PERMANENT SIGN OR STRUCTURE THAT WILL OBSTRUCT THE PUBLIC WAY MORE THAN SIX INCHES

15 Beattle St Cambridge MA 02138

SIGN CERTIFICATION FORM

CERTIFICATE OF NONAPPLICABILITY

A **TYPE "A" INTERNALLY ILLUMINATED PIN MOUNTED SIGN - FRONT ELEVATION AND SECTION**
Scale: NTS

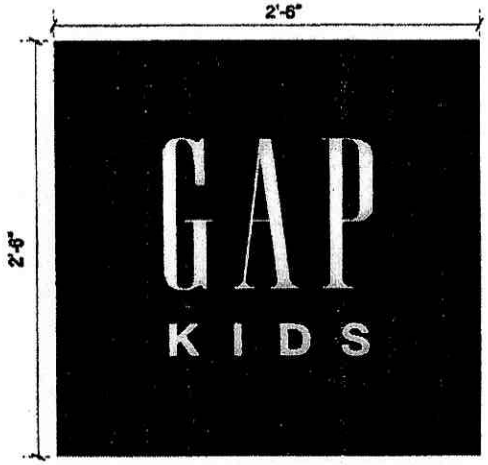
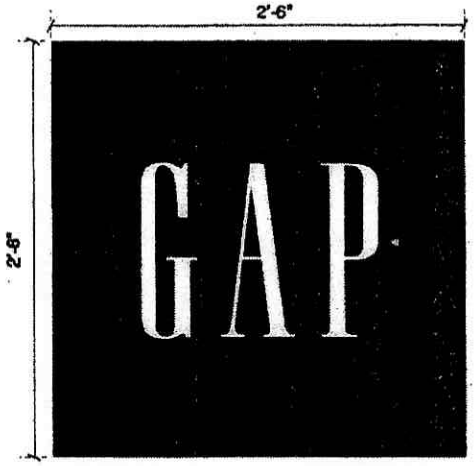
Sign conforms to requirements of Article 7.000: YES_____ NO V

Relevant sections: 7.16.22.B. Internal illumination of a projecting sign

COMMENTS: If the sign is externally lit, it conforms
